Sundry Notices and Reports on Wells

1. Type of Well GAS	5. Lease Number SF-078878		
2. Operator El Paso Natural Gas Company	6. If Indian, All.or Tribe Name		
3. Address & Phone No. of Operator PO Box 4289, Farmington, NM 87499	7. Unit Agreement Name Canyon Largo Unit		
4. Location of Well 910'S, 1675'W	8. Farm or Lease Name Canyon Largo Unit NP		
	9. Well No. 172		
	10. Field, Pool, Wildcat Ballard Pic. Cliffs		
	11. Sec. T. R. M. or Blk Sec. 27, T-25-N, R-7 -W NMMPM		
14. Permit No.	15. Elevations 6970' GR	12. County Rio Arriba	13. State NM
16. Intent to/Subsequent Report of :			
17. Describe proposed or completed operations:

Canyon Largo Unit NP #172
SW/4 Section 27, T-25-N, R-7-W
Rio Arriba County, New Mexico

Wellbore Schematics

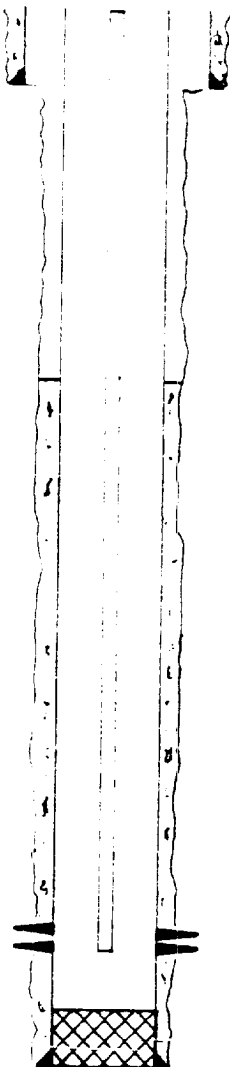
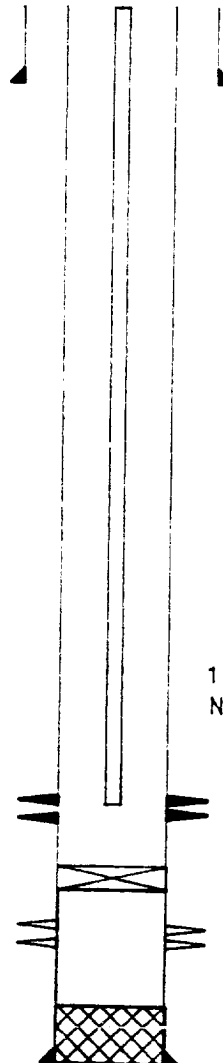
It is intended to plug back the Pictured Cliffs and recomplete in the Fruitland Coal formation in the following manner:

Set CIBP at 2630'. Pressure test to 3500 psi. Perforate at 2477-82', 2504-06', 2516-18', 2529-30', 2557-58', 2561-62', 2596-99', 2608-16' w/2 spf. Break down perms w/460 gal. of 7 1/2% HCl. Evaluate well. Fracture stimulate with 55,000# sand and 34,270 gal. fluid. Flow well back. Land 1 1/4" tbg at 2616'.

Squeeze the pictured cliffs perforations
with cement.

APPROVED
AS AMENDED
